10.0 Steam and Power Conversion System

The information in this section of the reference ABWR DCD, including all subsections, tables and figures, is incorporated by reference with the following departures and supplements.

10.1 Summary Description

Figure 10.1-1 Reference Steam and Power Conversion System

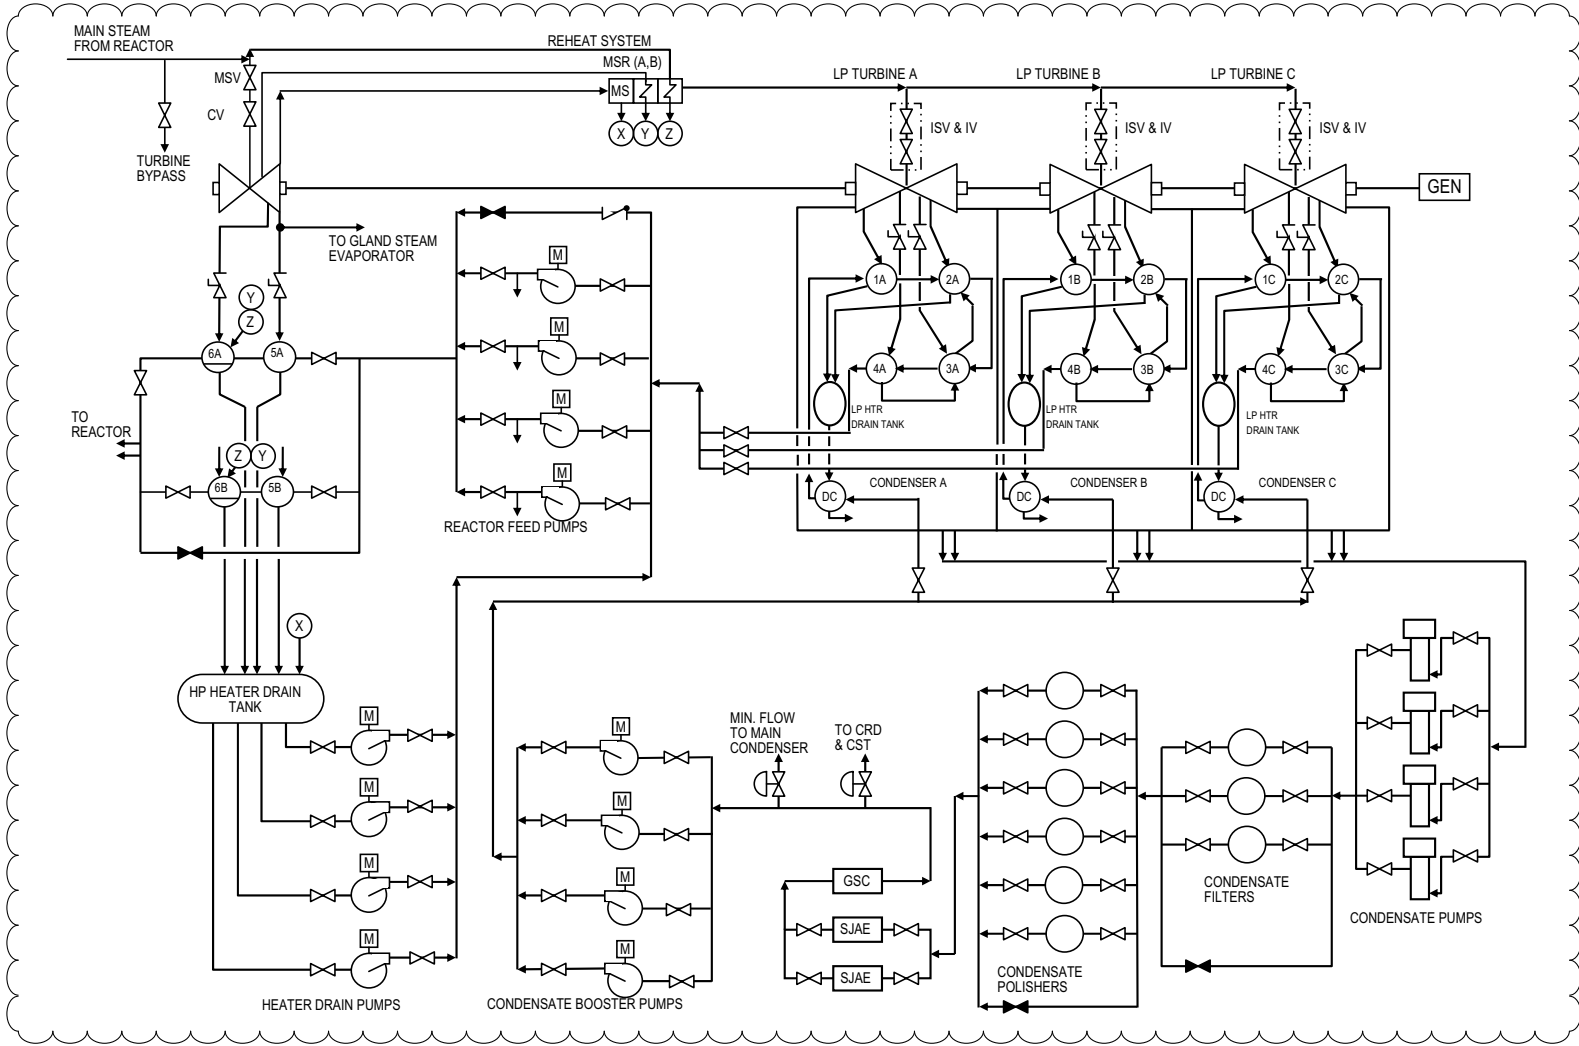
STP DEP 9.2-3 (Figure 10.1-1)

STP DEP 10.1-2 (Figure 10.1-1)

STP DEP 10.2-1 (Table 10.1-1, Figure 10.1-1)

Steam exhausted from the low-pressure turbines is condensed and deaerated in the condenser. The condensate pumps take suction from the condenser hotwell and deliver the condensate through the filters and demineralizers, gland steam condenser, steam jet air ejector condensers, ~~offgas recombiner condensers~~, and to the suction of the condensate booster pumps. The condensate booster pumps discharge condensate through the low-pressure feedwater heaters to the reactor feed pumps. The reactor feed pumps discharge through the high pressure feedwater heaters to the reactor.

~~Major S&PC System design features are summarized in Table 10.1-1. The system main conceptual features are illustrated on Figure 10.1-1, assuming a triple pressure condenser. This type of condenser and other site dependent ABWR plant features and parameters are reported herein based on typical central U.S. site conditions. They are given here to more completely define the ABWR Turbine Island standard design and to be used as references in reviewing future ABWR plant specific licensing submittals, and confirming that such submittals are indeed consistent with the standard design. Nothing in the ABWR Standard Plant design is meant to preclude the use of a once-through cooling system and a single pressure condenser nor will such changes affect the Nuclear Island.~~
